Appendix I of RNTPC  
Paper No. A/YL-TYST/1263

**APPLICATION FOR PERMISSION  
UNDER SECTION 16 OF  
THE TOWN PLANNING ORDINANCE  
(CAP. 131)**

(a) Proposed use(s)/development 擬議用途/發展	Proposed temporary warehouse for storage of paper and workshop (shredding paper)  (Please illustrate the details of the proposal on a layout plan) (請用平面圖說明擬議詳情)

**A/YL-TYST/1263 DD 119 Pak Sha Tsuen**

Structure 1 and Structure 2 Layout Plan A-1

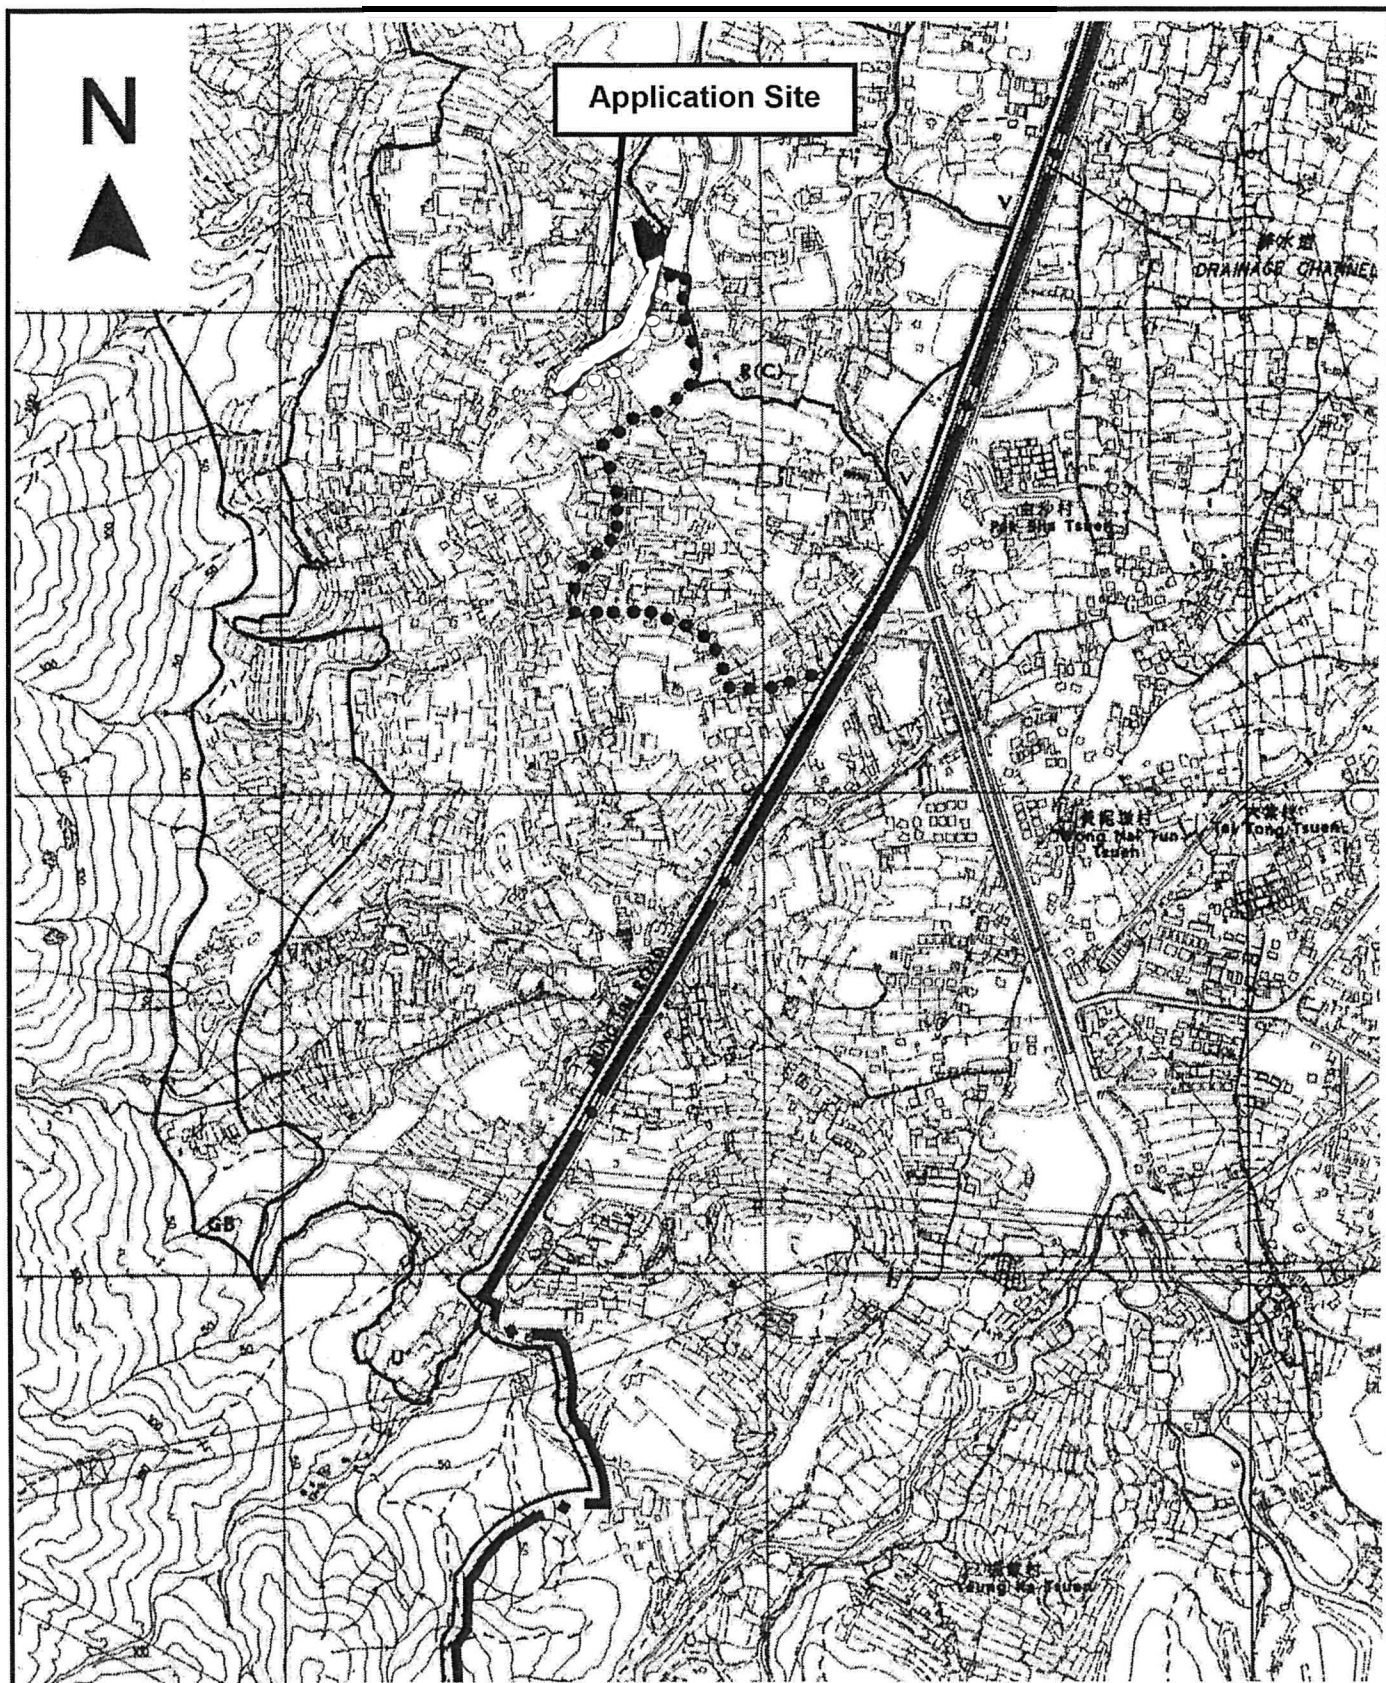
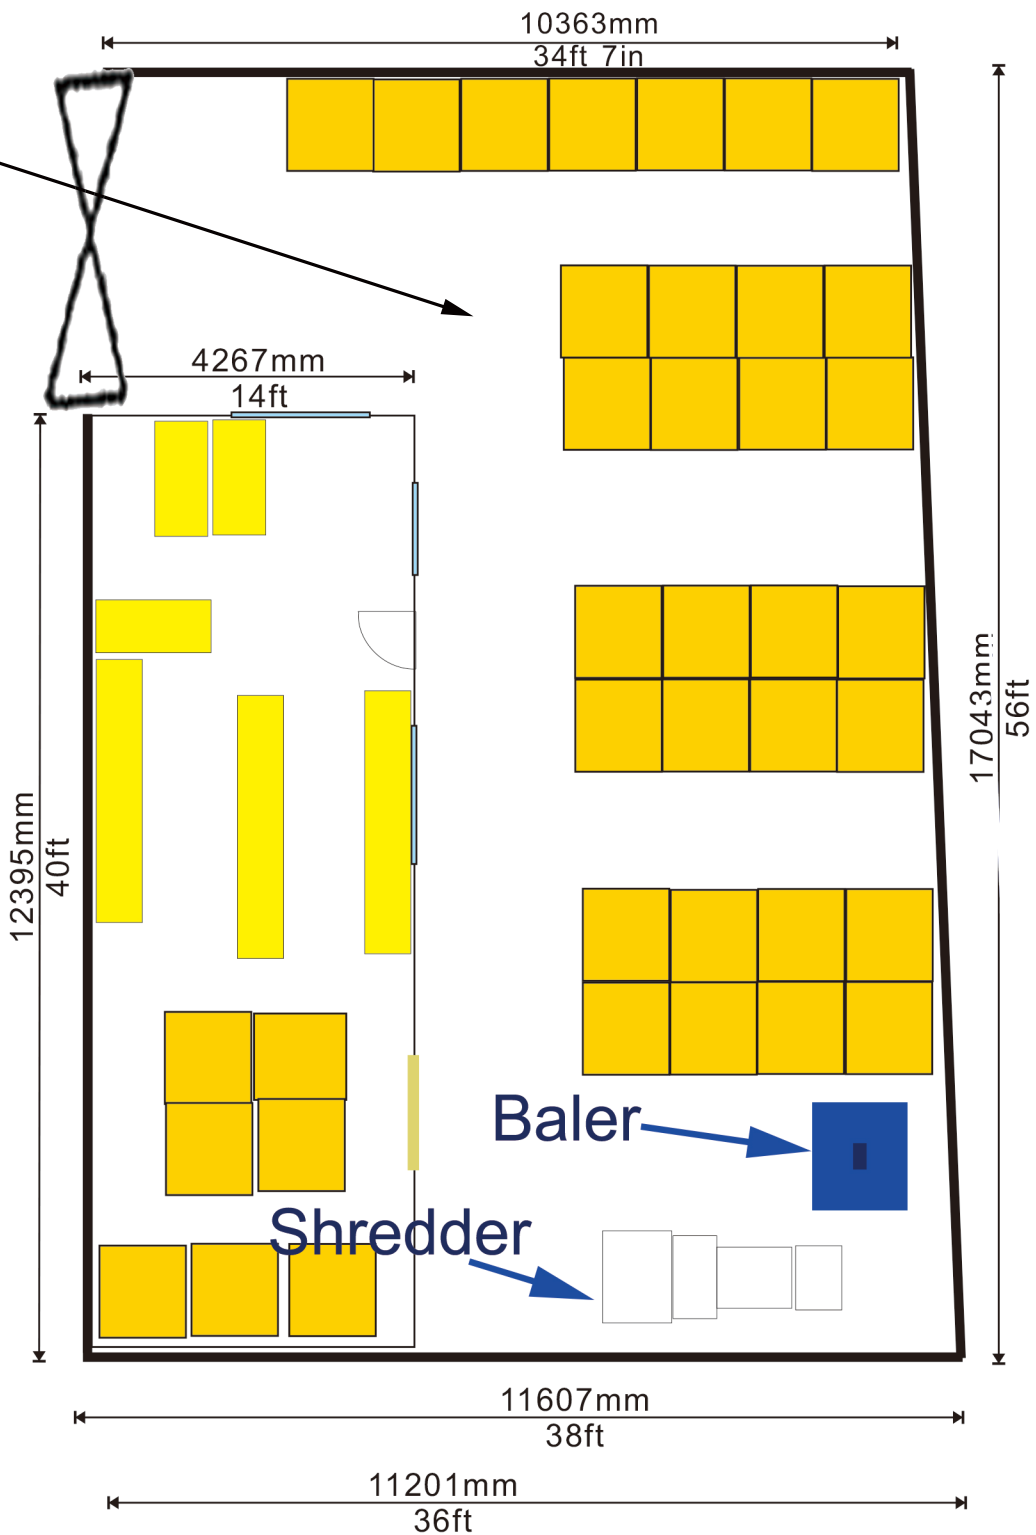
- no objection in principle to the proposed development from the public drainage point of view; and
- should the Town Planning Board (the Board) consider the application is acceptable from the planning point of view, approval conditions requiring the submission, implementation and maintenance of a drainage proposal to the satisfaction of the Director of Drainage Services or of the Board should be stipulated.

No objection in principle to the proposal subject to fire service installations being provided to his satisfaction.

- (g) to note the comments of the Director of Fire Services (D of FS) that:
- (i) in consideration of the design/nature of the proposal, fire service installations (FSIs) are anticipated to be required. Relevant layout plans incorporated with the proposed FSIs should be submitted to his department for approval;

- (ii) the layout plans should be drawn to scale and depicted with dimensions and nature of occupancy, and the location of proposed FSIs to be installed should be clearly marked on the layout plans; and

Structure 1 and Structure 2 Layout Plan A-3  
Location of Fire Extinguisher

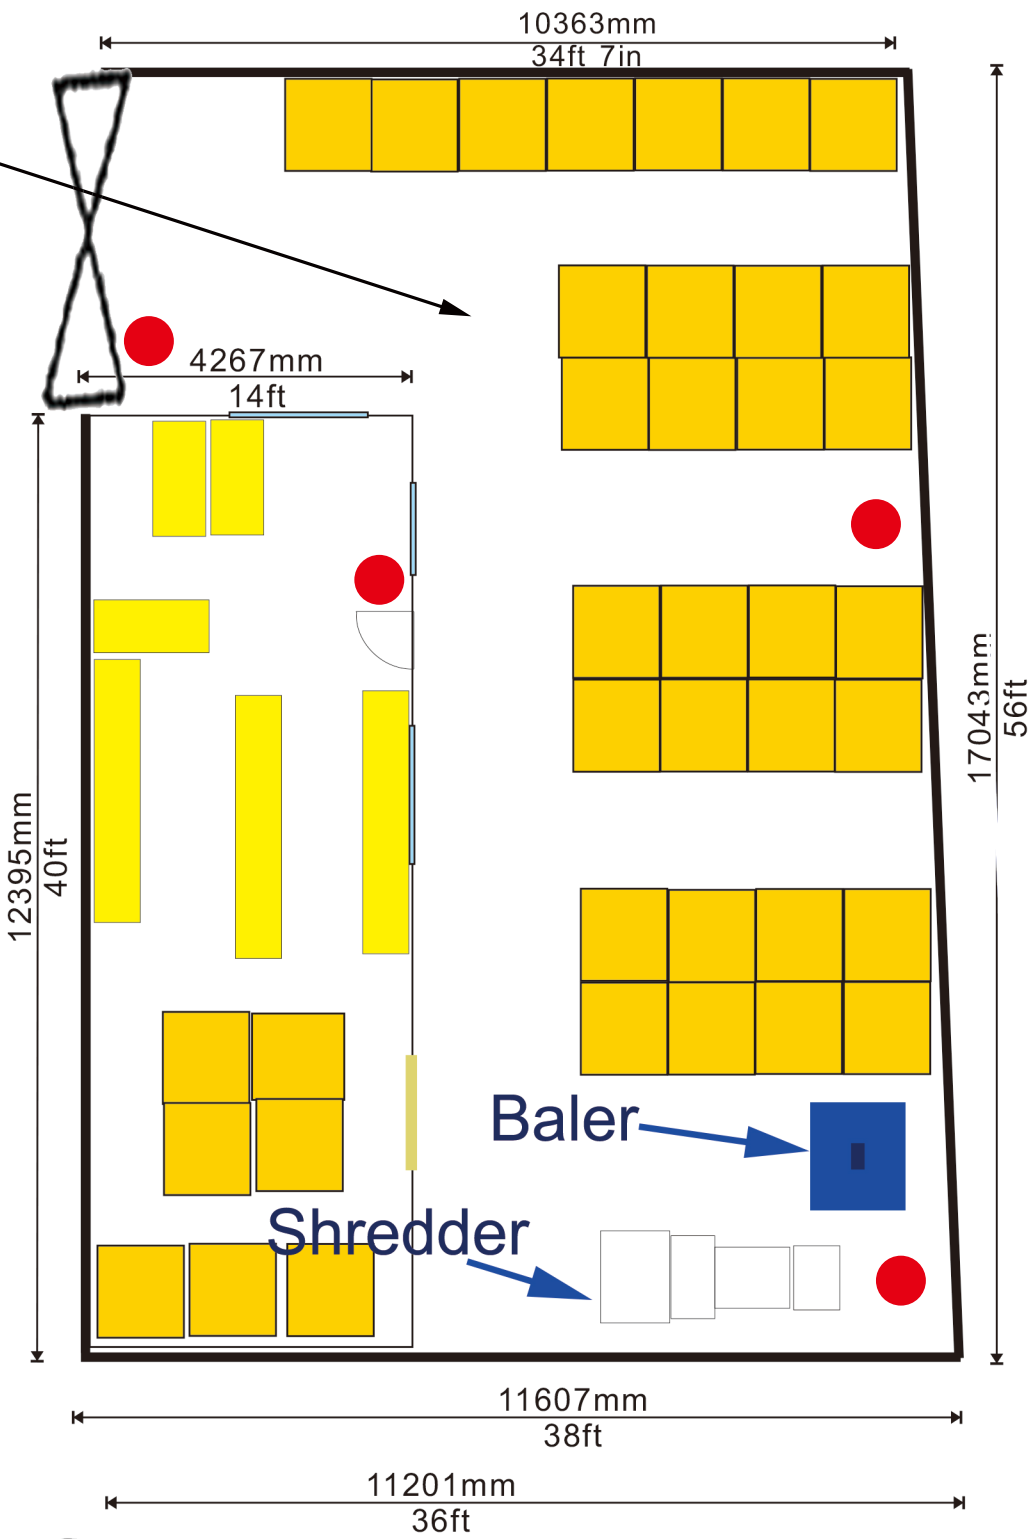
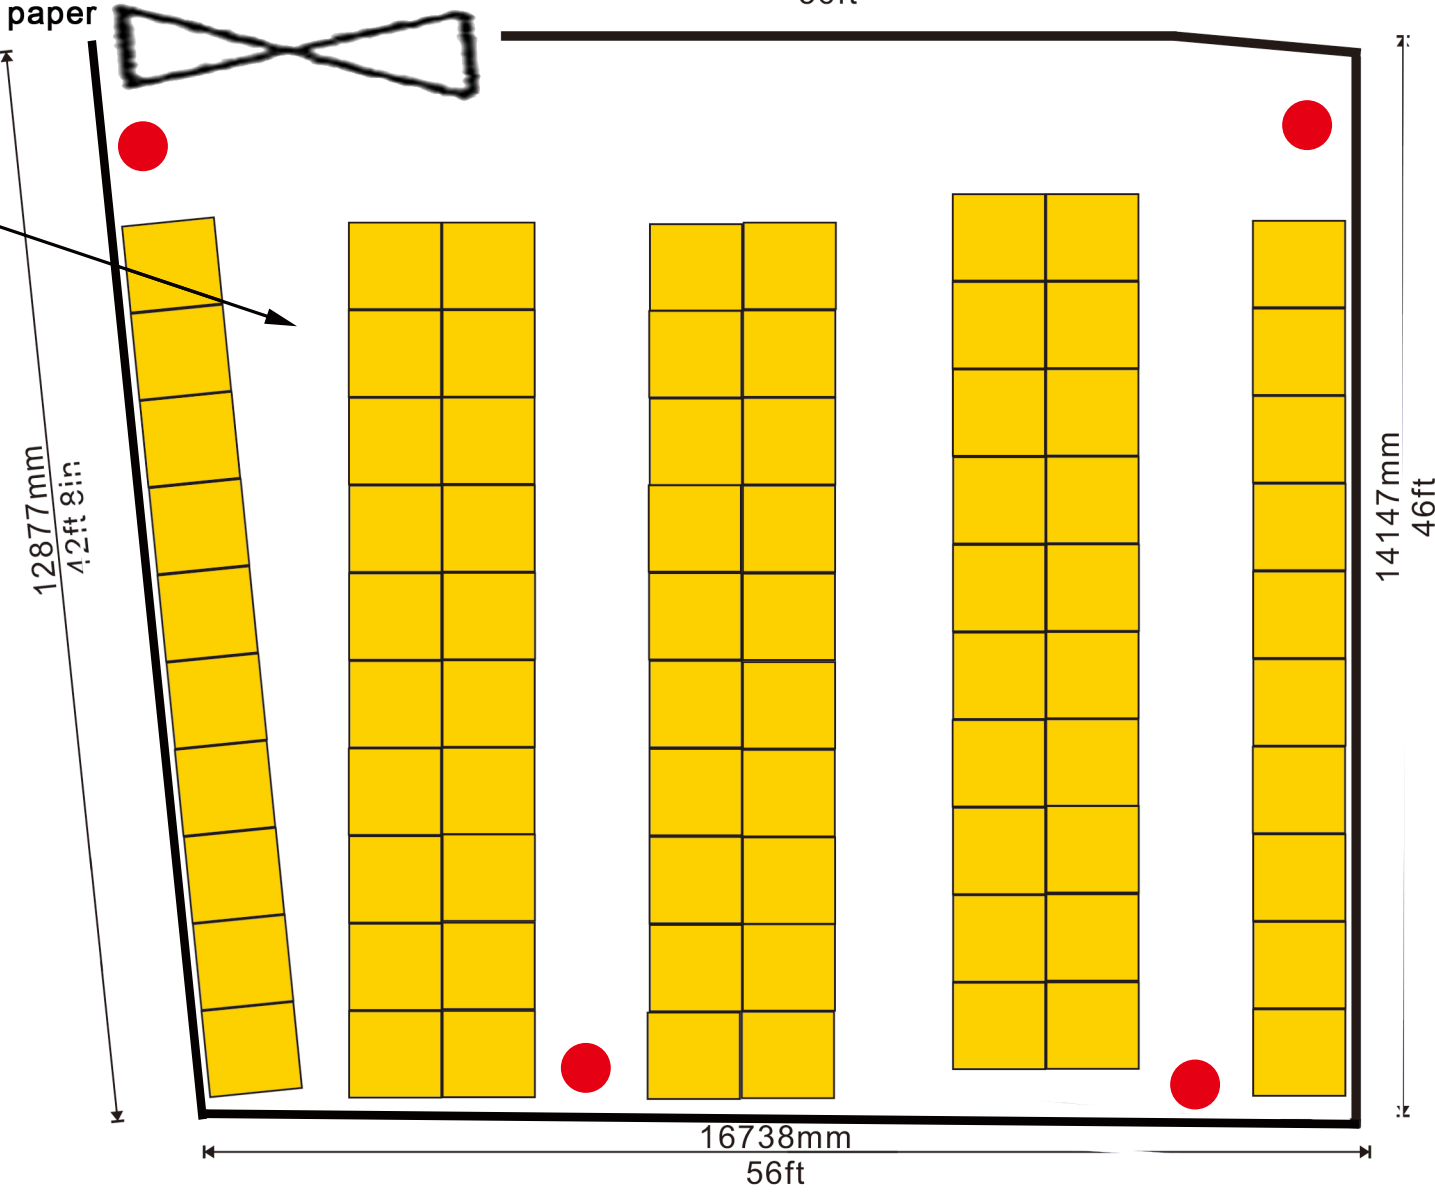
Again conditions of 1097 were not fulfilled and approval was finally revoked on 25 Nov 2023 FOR FAILURE TO FULFILL FIRE AND DRAINAGE CONDITIONS.

**HOWEVER, WITH THE INCREASING NUMBER OF FIRES AND THE NATURE OF THE PLANNED STORAGE – PAPER – FAILURE ON THE PART OF BOTH GOVT DEPTS AND TPB TO ENSURE THAT THE COMMUNITY IS SPARED THE IMPACT OF PREVENTABLE FIRES IS NOTHING SHORT OF MALADMINISTRATION.**

Approval should only be granted if fire prevention measures are already in place.
